ITEM 1**Conversion of existing pub/ club (former church) to form 9 residential units and external landscaping at the sports bar, adjacent 37 Holywell Street for City Realty Ltd.**

Plot No: 2/1250

Committee Date: 14th March 2022

First Floor Plan As Proposed

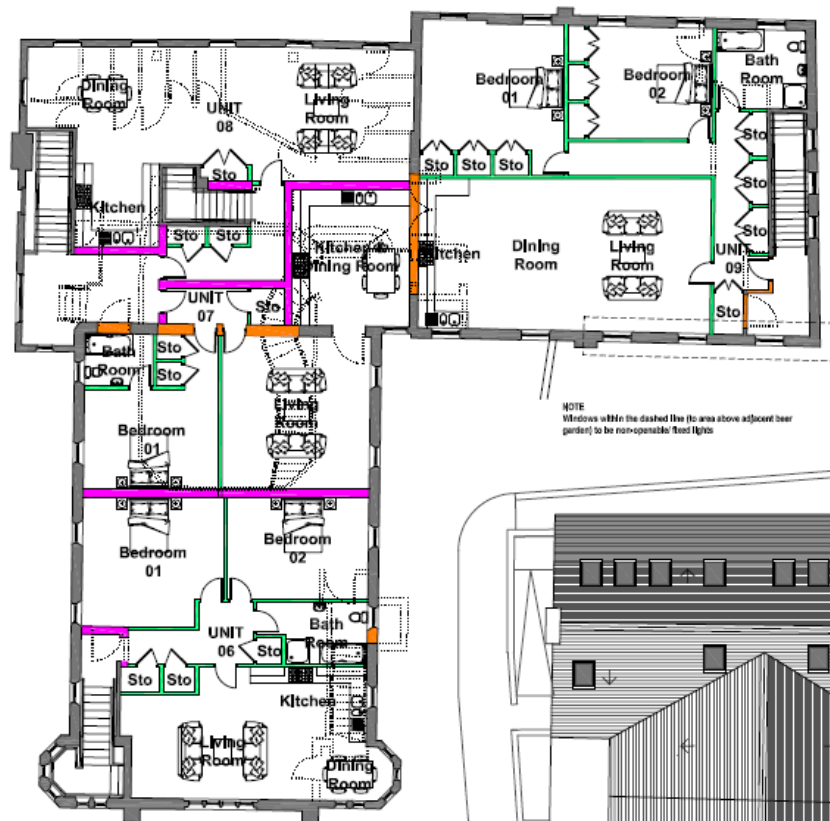
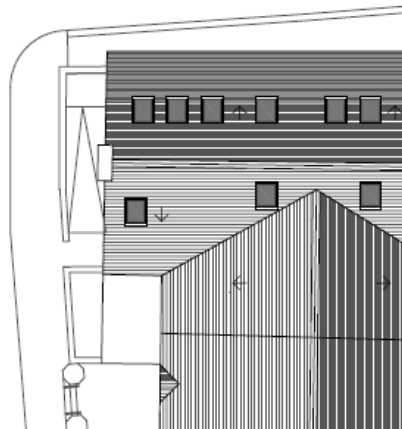
From plan 202 submitted with the application (proposed basement, first and second floor), it does appear as though all the windows on the facades facing towards Ritzy's court yard will be openable windows. If windows are opened this will allow for music to enter into the properties and potentially impact on the proposed occupants.

As you will see from the attached screen shot showing floor plans, the developer has proposed bedrooms near to locations MP3 and MP4.

6. The windows to the living area of unit 9 shall be fixed non-openable windows as shown on the Basement, first and second floor plan and roof plan no. 202 Rev D received 24.11.2021 and shall remain so throughout the life of the development.

4.20 Image to show the noise monitoring locations:

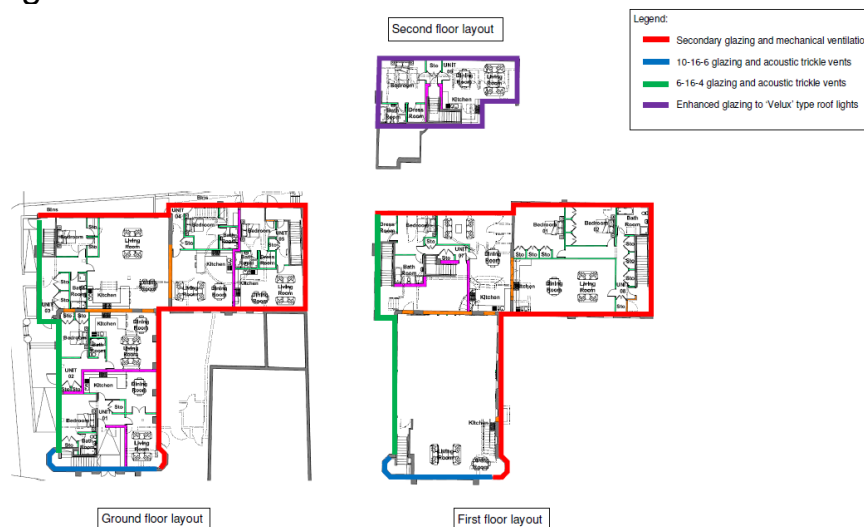
Also seen in the images (seen in the noise report section above), the monitoring locations taken from the noise report supporting this application. You will see that monitoring point 5 (MP5) is the closest monitoring location to Ritzy's.

Noise monitoring was carried out near to these locations as shown as MP3 and MP4 on the attached 'monitoring location' plan.

Locations MP3 and MP4 would be impacted on by music noise from adjacent businesses; one of which plays music until 5am during summer months.

If I have interpreted the noise report correctly, there is no data supporting long term/overnight monitoring at locations MP3 and MP4.

The applicant will need to provide an updated noise assessment, which takes into account long term/overnight monitoring at locations MP3 and MP4 at times when entertainment noise (music and people) are at their loudest. The updated assessment must also take into account frequency analysis at all monitoring locations near to where the residential accommodation is planned. The noise consultant must agree the methodology with environmental health prior to undertaking on site measurements.

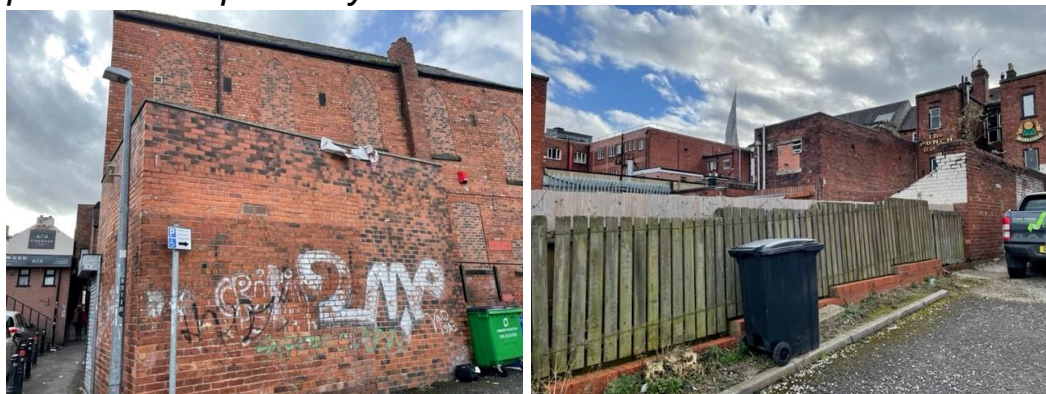
I have attached two photos (court yard 1 and court yard 2) which show the view from the rear of Ritzy's to the building for the proposed development. The court yard at Ritzy's is flanked by the walls of the former church.

The noise monitoring results show an overall/average for a period of time and do not appear to specify a frequency analysis.

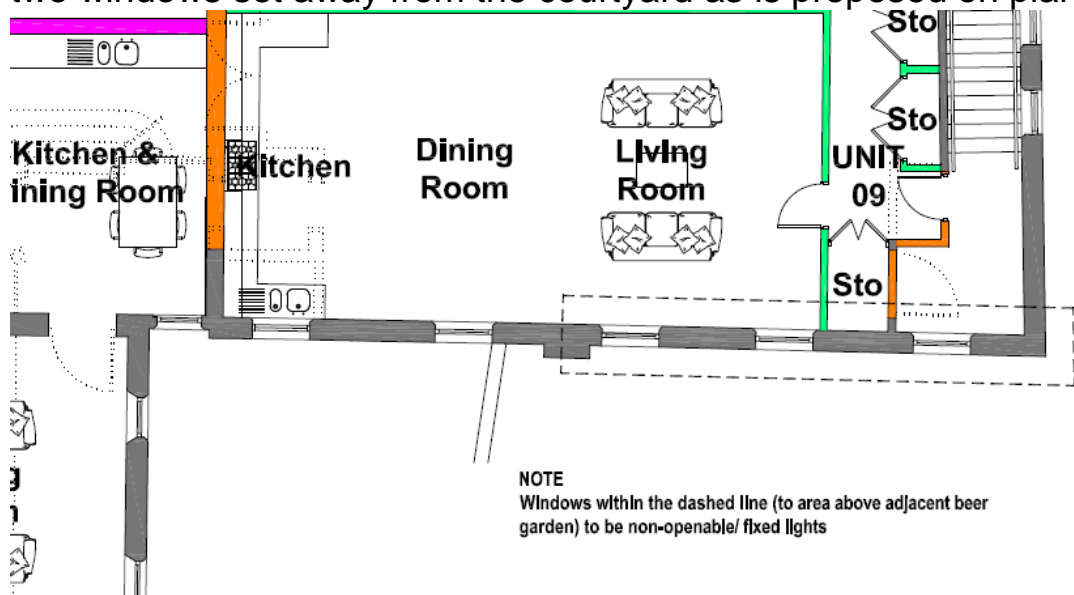
In the current format, the noise assessment (reference: NA/1039/21/050 V1.0) does not appear to be as detailed as is necessary to calculate the potential impact on residential occupiers of the proposed development. The report does not appear to consider bass/low frequencies which can easily penetrate through closed windows and brick walls. Furthermore, the report does not specify the height that the microphone was placed. If the microphone was placed at 1.5m above ground level, some of the existing buildings would shield the audible noises at those monitoring locations. The bedrooms in the proposal are at first and second floor

and the monitoring position needs to be more representative of these locations.
